- TO:** All U.S. Ford and Lincoln Mercury Dealers
- SUBJECT:** Safety Recall 05S34: Supplement #2
Certain 2004 Model Year F250/350/450/550, Excursion, and E350/450 Vehicles
Equipped with 6.0L Diesel
Fuel Injector Control Module Wiring Harness Repair

New! REASON FOR THIS SUPPLEMENT

This bulletin is being re-issued to re-assign the labor operation for the Customer Assurance Test Drive to Safety Recall 05S34.

- *Add an additional labor operation for FICM wire harness inspection; add a reference for Voluntary Emission Recall 05E15; and revise the Attachment III, IV, and V technical information.*

FIGURE 5

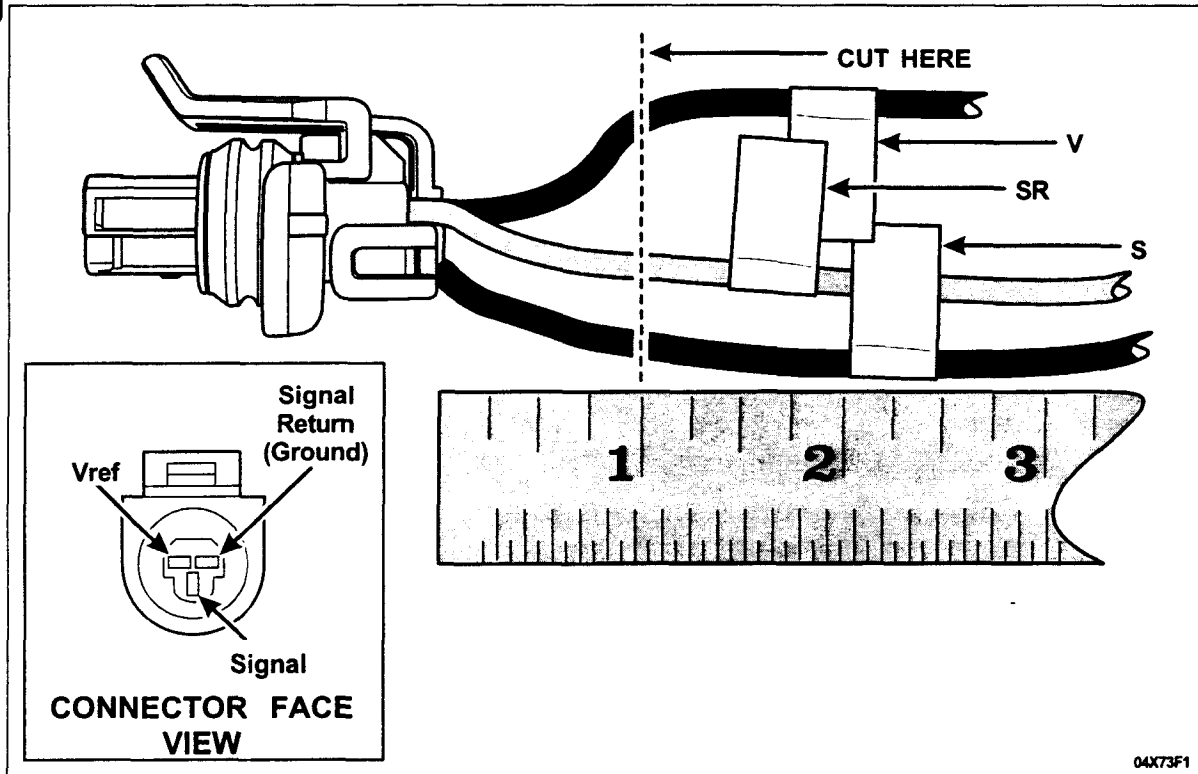
- CAUTION:** The replacement connector has only one (1) color wire, so location identification is crucial for a proper repair.
Identify each wire leading to the connector (Vref, Ground and Signal). Note the locations of each wire relative to the connector face view provided. Place the identification tags at least a few inches away from the connector. See Figure 5.
- Cut the wires about 25 mm (1 inch) behind the connector on the vehicle harness **MAKING SURE TO LEAVE THE IDENTIFYING TAGS ON THE HARNESS** and retain the old connector for reference. See Figure 5.

NEW

- Strip about 7 mm (1/4 inch) of insulation from the wires on the **new** pigtail.
- Using the crimp tool provided in the Rotunda Tool Kit, install the butt splice connectors provided in the service kit onto the replacement connector pigtail.
- Strip about 7 mm (1/4 inch) of insulation from the wires on the vehicle harness.
- Position the heat shrink over the wires on the **new** connector.
- Matching the wires on the pigtail to the identifying tags on the vehicle harness, crimp the **new** butt connectors to the vehicle harness. Lightly tug on the wires to make sure you have a good, tight splice.

FIGURE 10

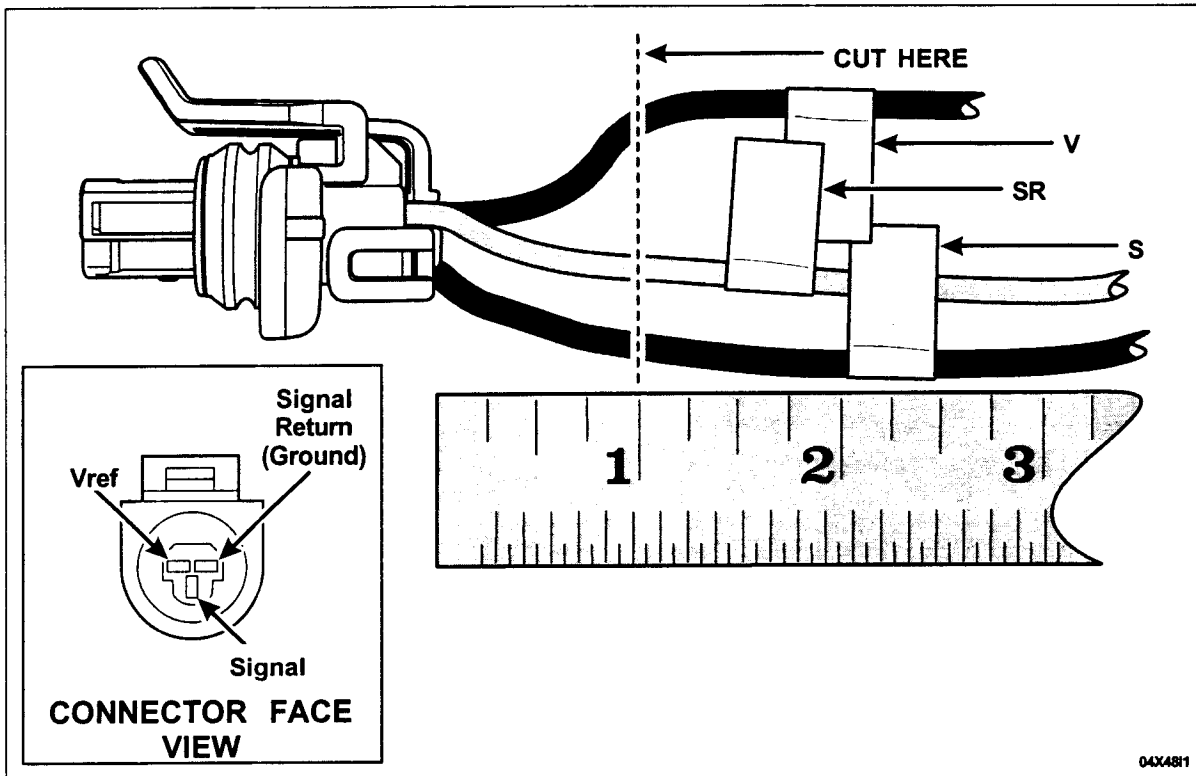
Identify each wire leading to the connector (Vref, Ground and Signal). Note the locations of each wire relative to the connector face view provided. Place the identification tags at least a few inches away from the connector. See Figure 10.

4. Cut the wires about 25 mm (1 inch) behind the connector on the vehicle harness **MAKING SURE TO LEAVE THE IDENTIFYING TAGS ON THE HARNESS** and discard the old connector. See Figure 10.

NEW

5. Strip about 7 mm (1/4 inch) of insulation from the wires on the **new** pigtail.
6. Using the crimp tool provided in the Rotunda Tool Kit, install the butt connectors provided in the service kit onto the replacement connector pigtail.
7. Strip about 7 mm (1/4 inch) of insulation from the wires on the vehicle harness.
8. Position the heat shrink over the wires on the **new** connector.
9. Matching the wires on the pigtail to the identifying tags on the vehicle harness, crimp the **new** butt connectors to the vehicle harness. Lightly tug on the wires to make sure you have a good, tight splice.
10. Position the heat shrink tubing over the butt splice connectors, then using the provided Flameless Heat Gun and deflector, heat the tubes on the vehicle harness until they shrink and adhesive flows from the ends, indicating a water-tight seal.
